TO: Mercedes-Benz Dealer Principals, General Managers, Sales Managers, Service Managers, Parts Managers	FROM: Gregory Gunther, Department Manager, Vehicle Compliance and Analysis, Engineering Services
RE: <b>Service Campaign Launch Notification</b> <b>Install New Coolant Line</b> <b>MY20-21 CLA-Class and GLA-Class (118 and 247 platform)</b>	DATE: July 22, 2022

Campaign No. 2022060006, July 2022

SUBJECT: **Model CLA-Class and GLA-Class (118 and 247 platform)**  
**Model Year 2020-2021**

## **Install New Coolant Line**

Figure 1

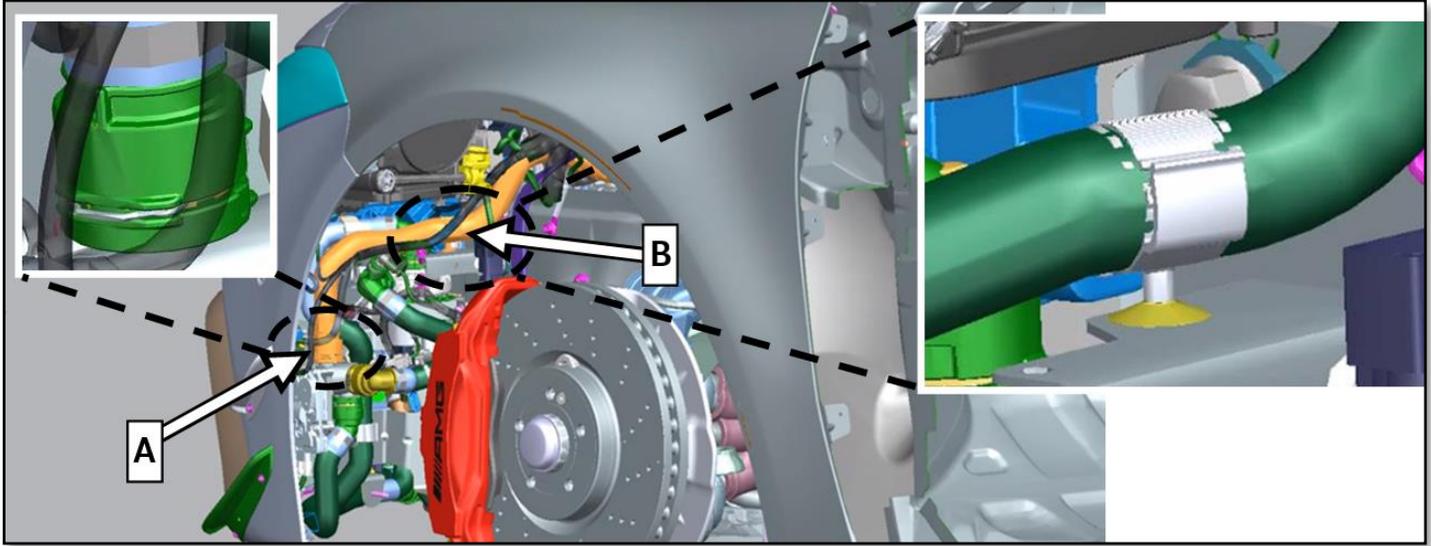
1. Drain coolant.  
 For basic data, see AR20.00-P-1142MFG.
2. Remove front part of front left fender liner.  
 For basic data, see AR88.10-P-1301MFA.
3. Release and remove coolant line **(A, Figure 1)** at switchover valve and open retaining clip **(B, Figure 1)** of coolant line.

Figure 2

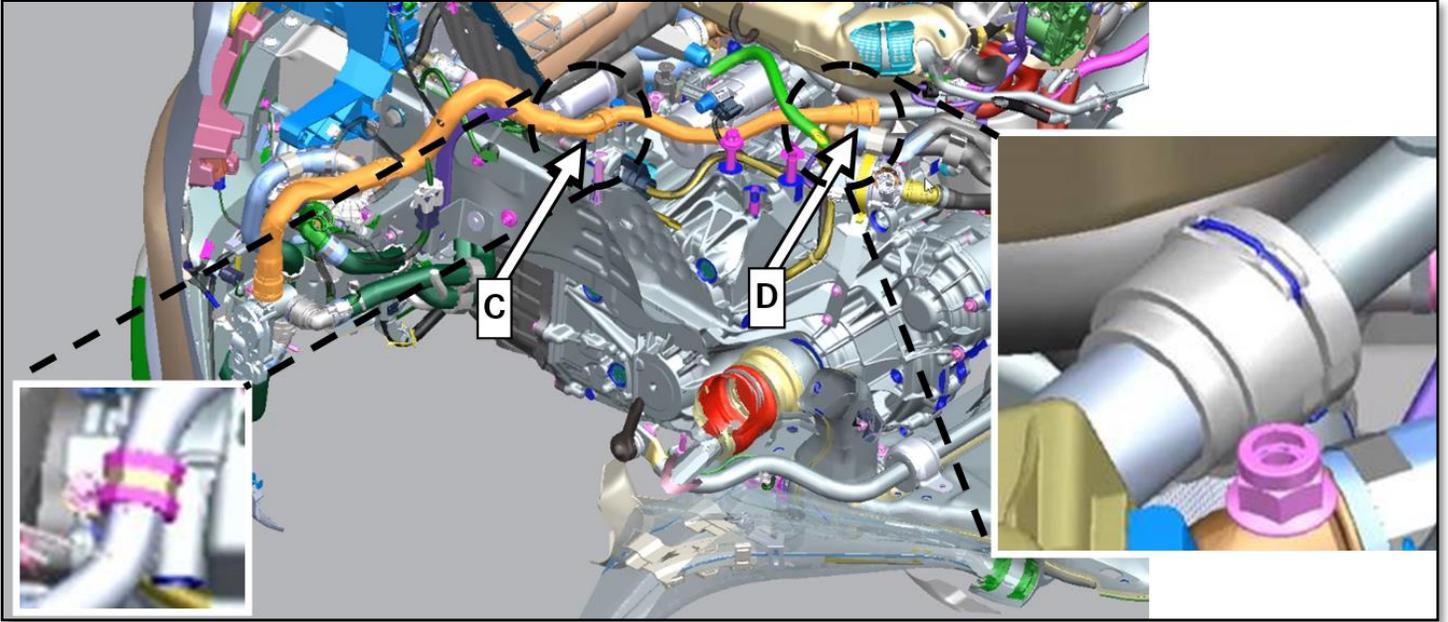
7. Release retaining clamp (C, Figure 2) on transmission, release coolant line (D, Figure 2) and remove.

8. Assemble with new coolant line in reverse order.
